UTILITY PLAN
STA. 140+00 TO 145+00

FARRINGTON HIGHWAY INTERSECTION IMPROVEMENTS
 AT NANAKULI AVENUE AND HALEAKALA AVENUE
 Federal-Aid Project No. STP-093-1(22)

UTILITY PLAN
STA. 150+00 TO 155+00

CONTRACT CHANGE ORDER NO. 12 1st SUPPLEMENT

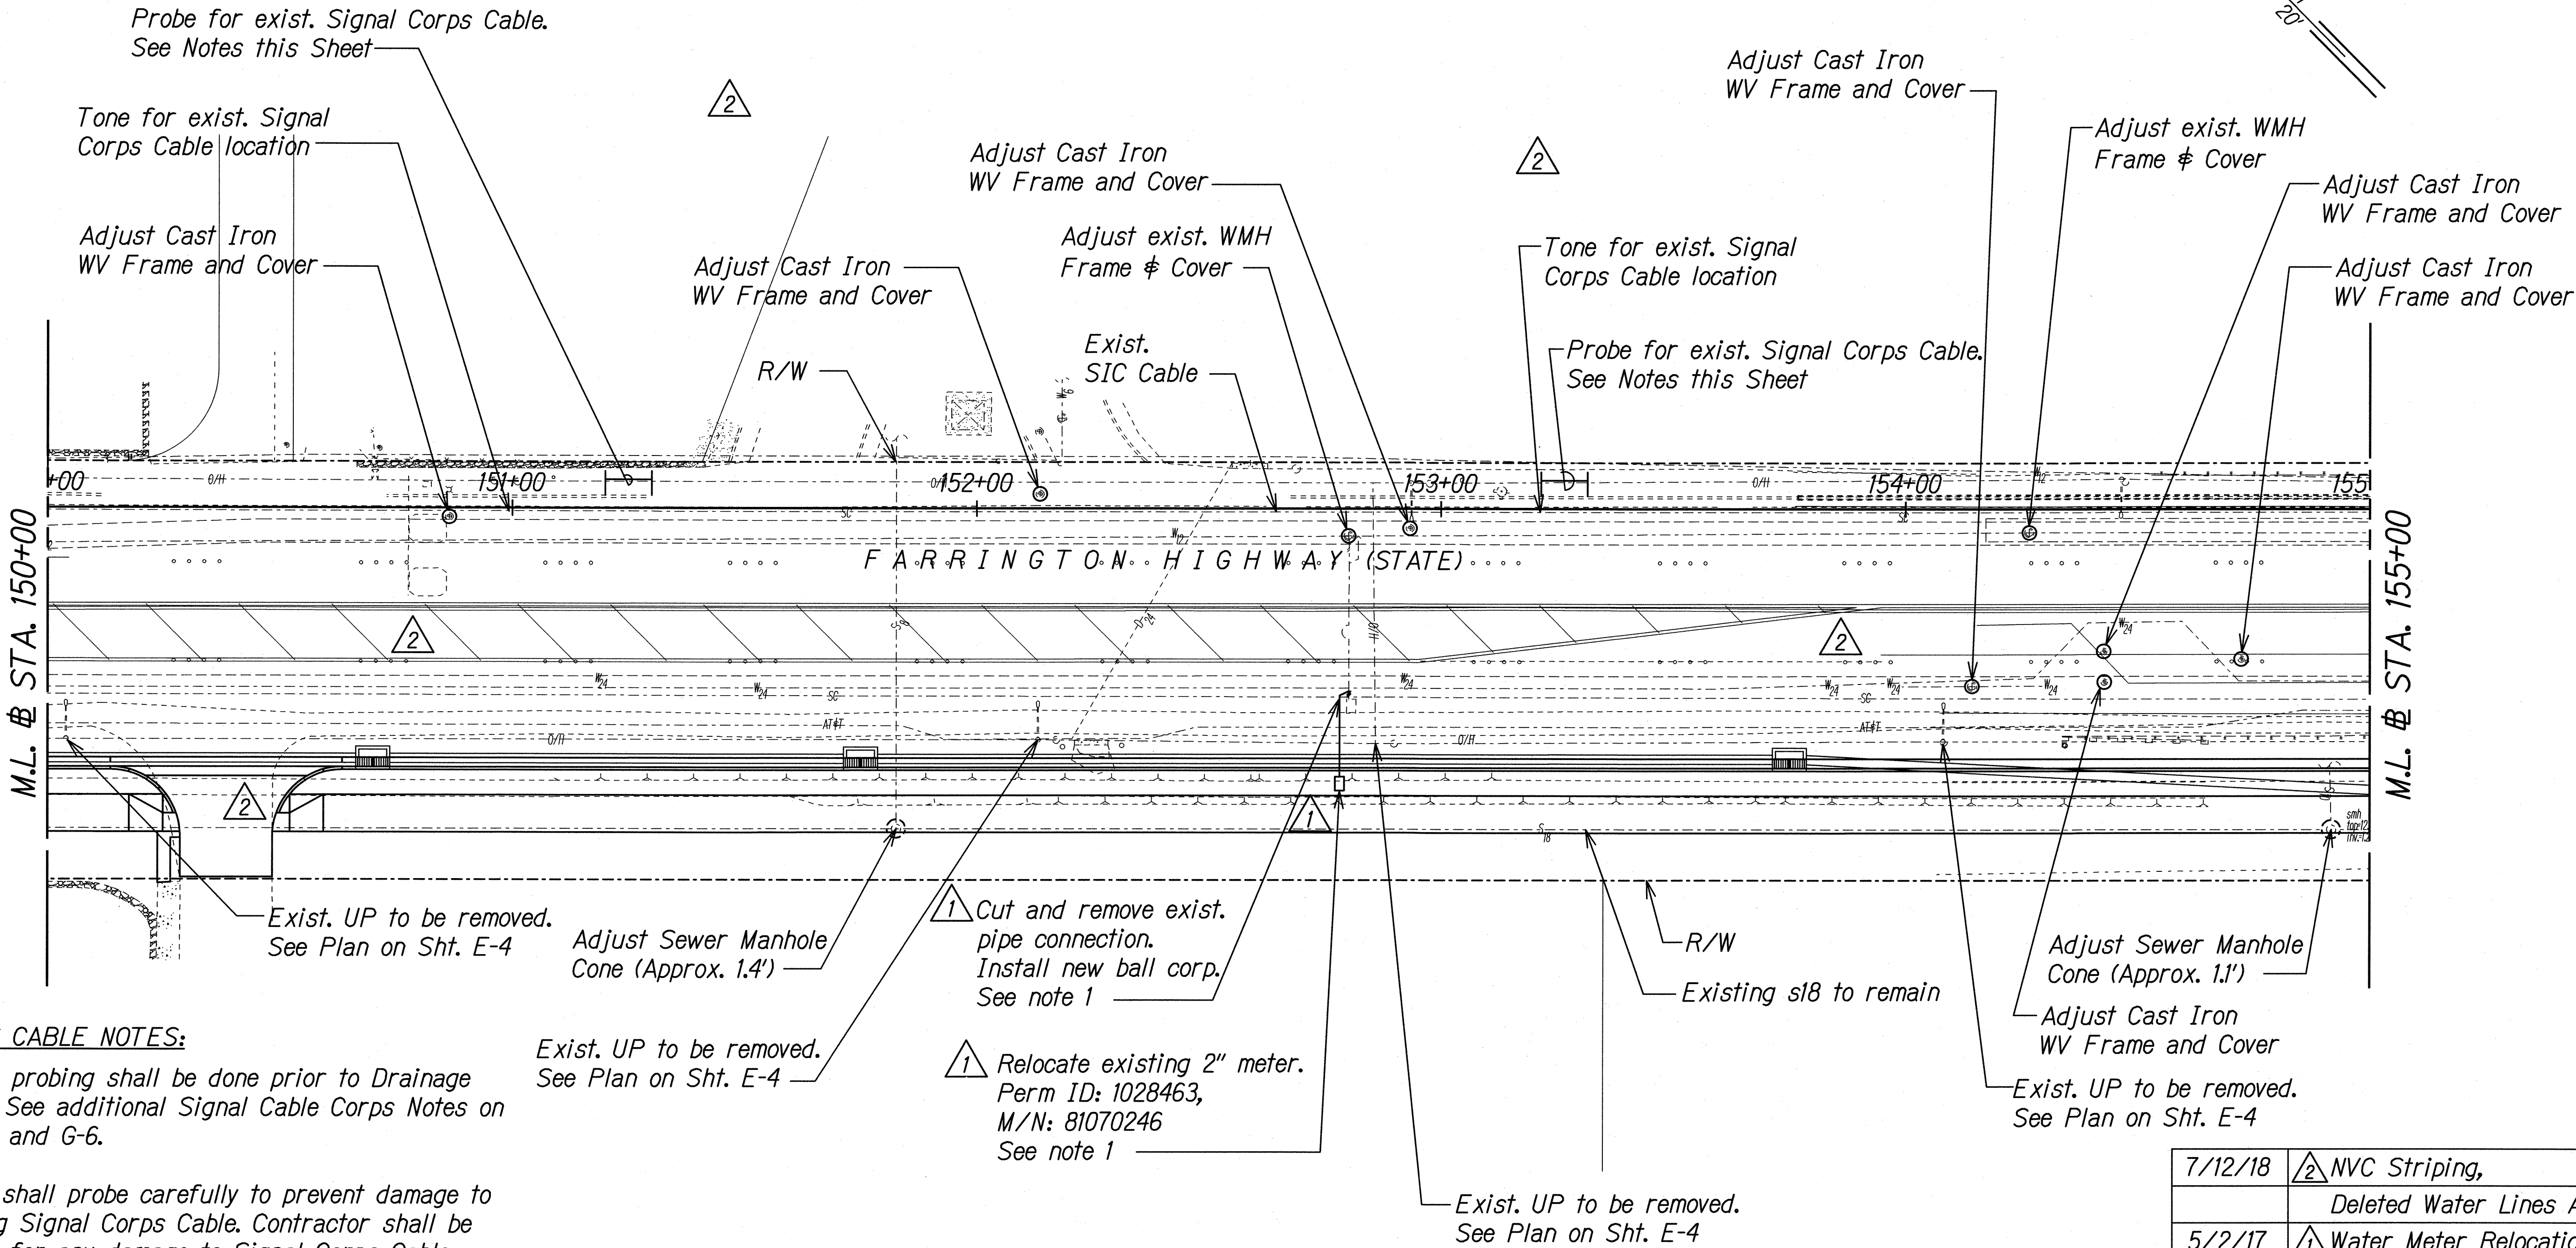
7/12/18	2 NVC Striping,
	Deleted Water Lines A & B
5/2/17	1 Water Meter Relocation
Date	Revision

- NOTES:**
- Probe for existing ball corp. servicing exist. WM.
Cut exist. 2-1/2" lateral @ exist. edge of pavement.
Extend 2-1/2" lateral and install new Type III box in new sidewalk.
Install new 2-1/2" ball corp.

- Exist. UP to be removed. See Plan on Sht. E-4
- 1 Cut and remove exist. pipe connection. Install new ball corp. See note 1
- 1 Relocate existing 2" meter. Perm ID: 1028463, M/N: 81070246 See note 1

UTILITY PLAN
STA. 155+00 TO 160+00

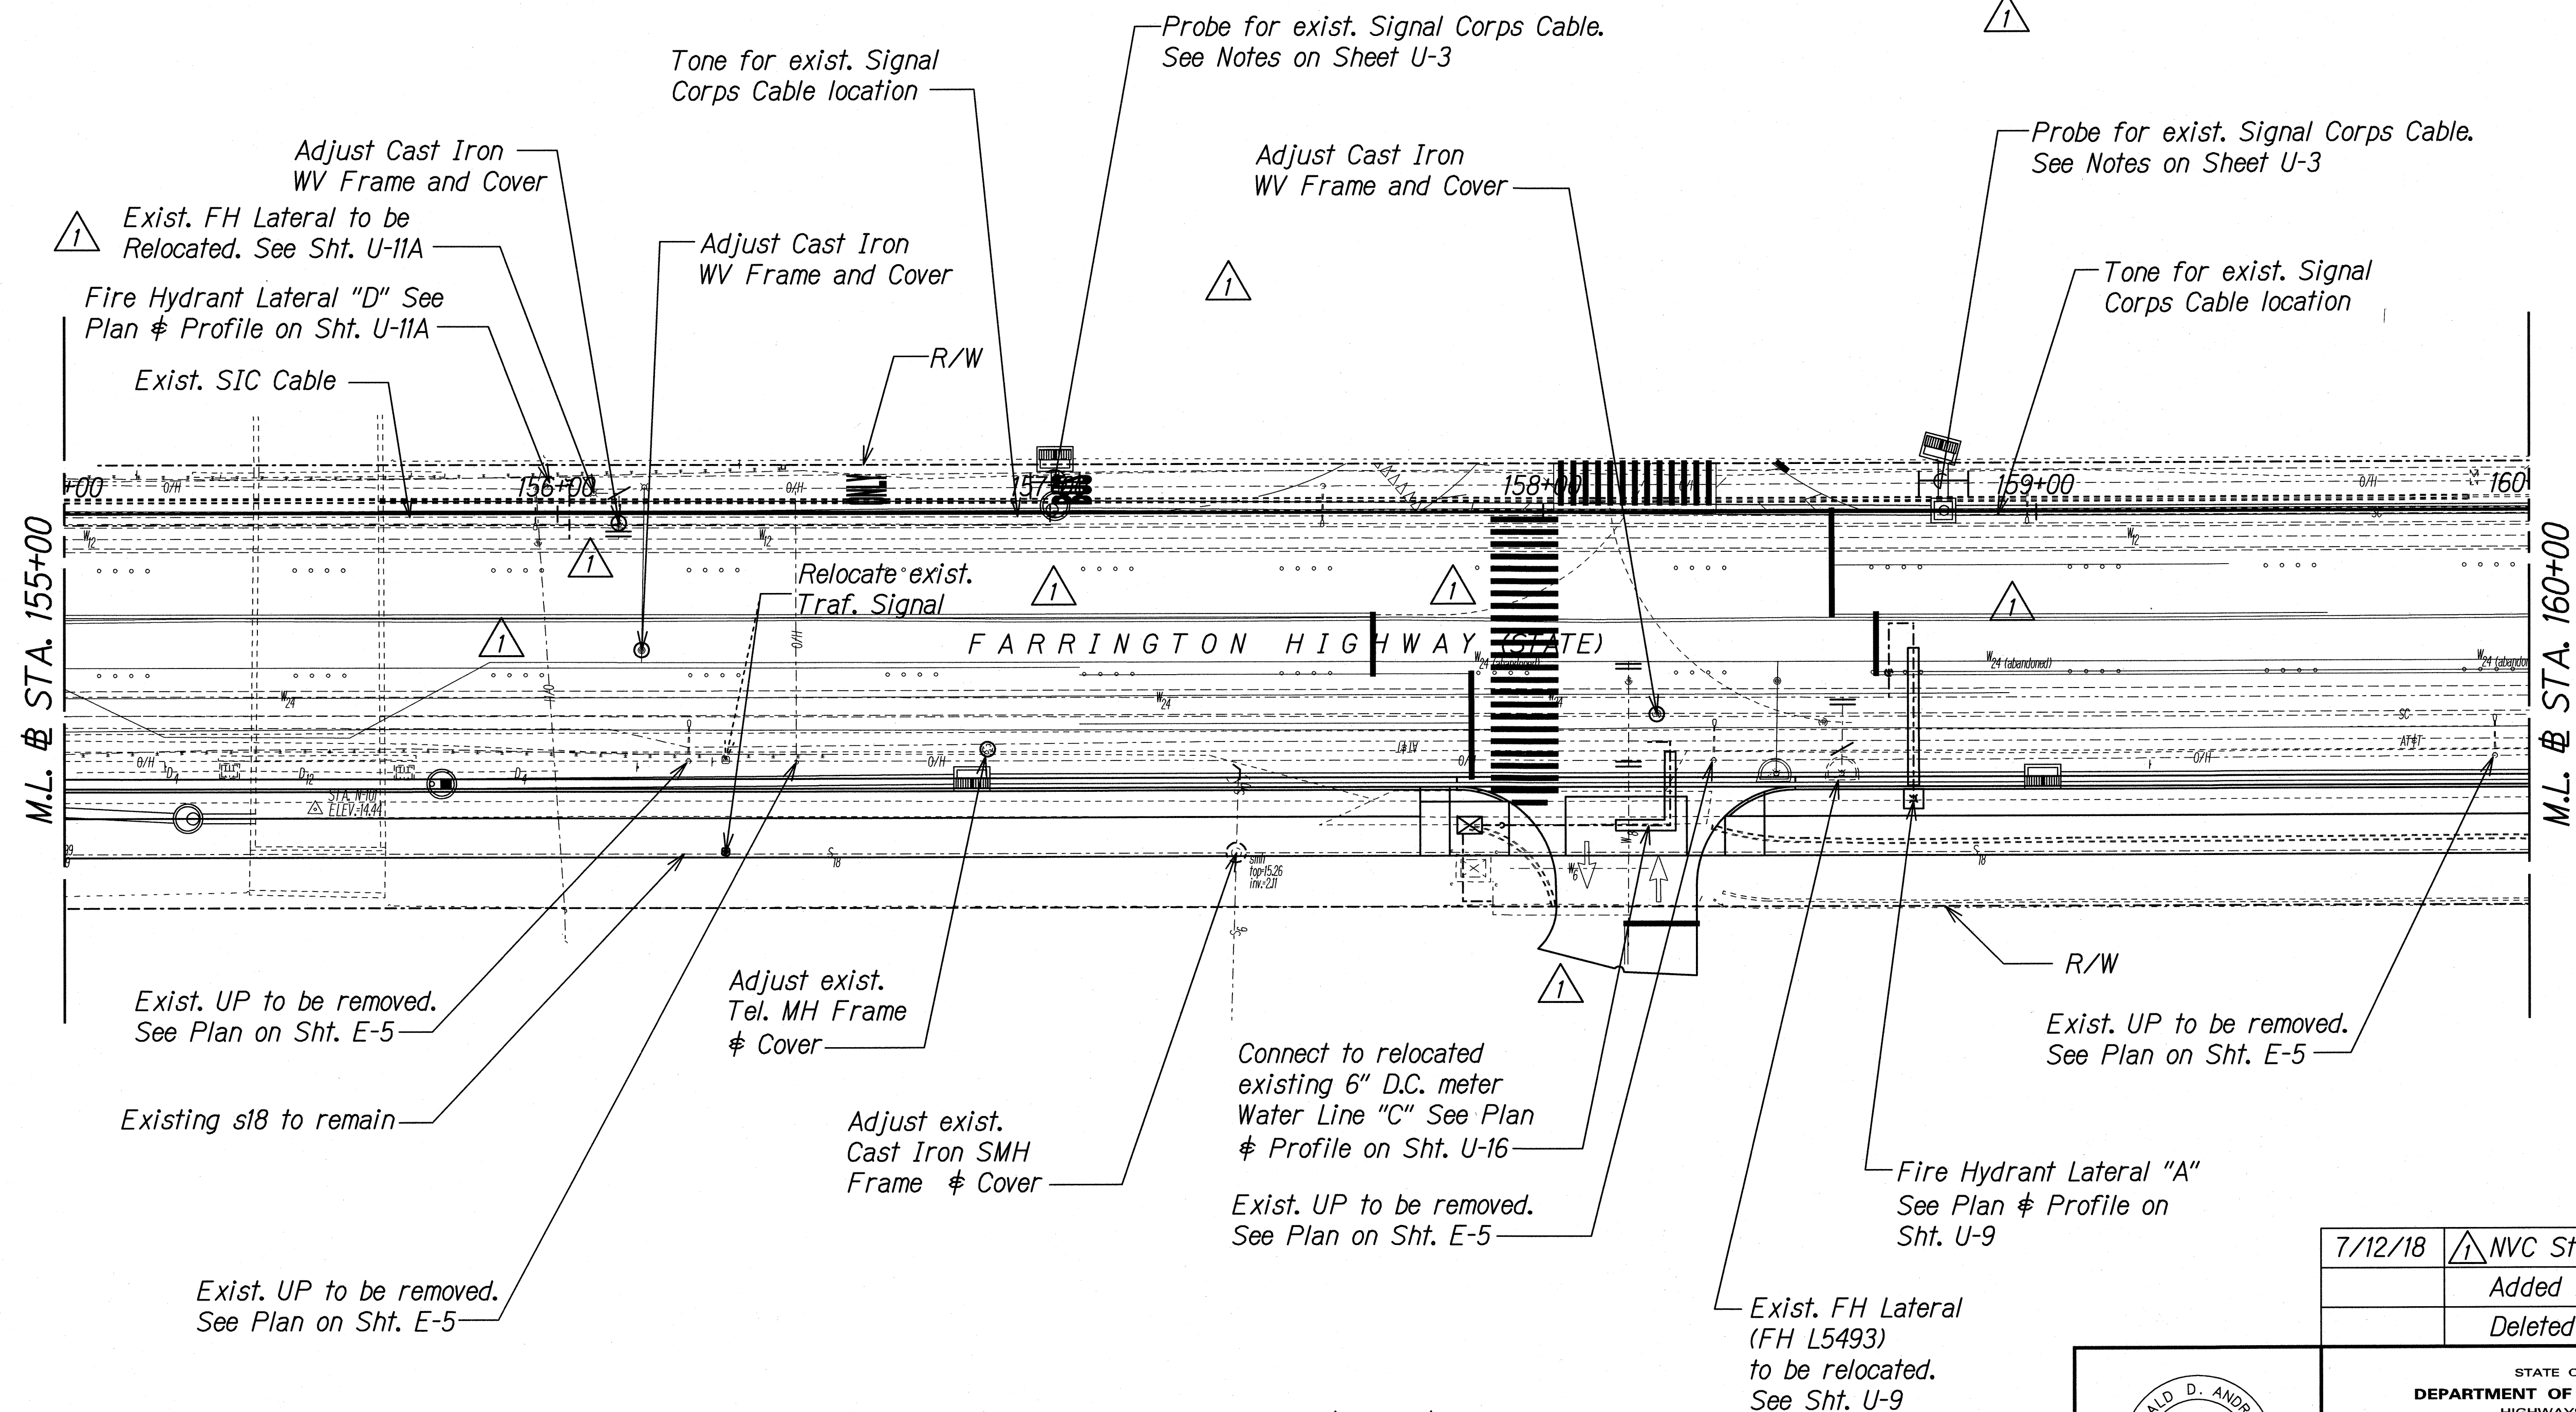
7/12/18	 NVC Striping,
	Added FH Lateral "D",
	Deleted Water Lines D & E
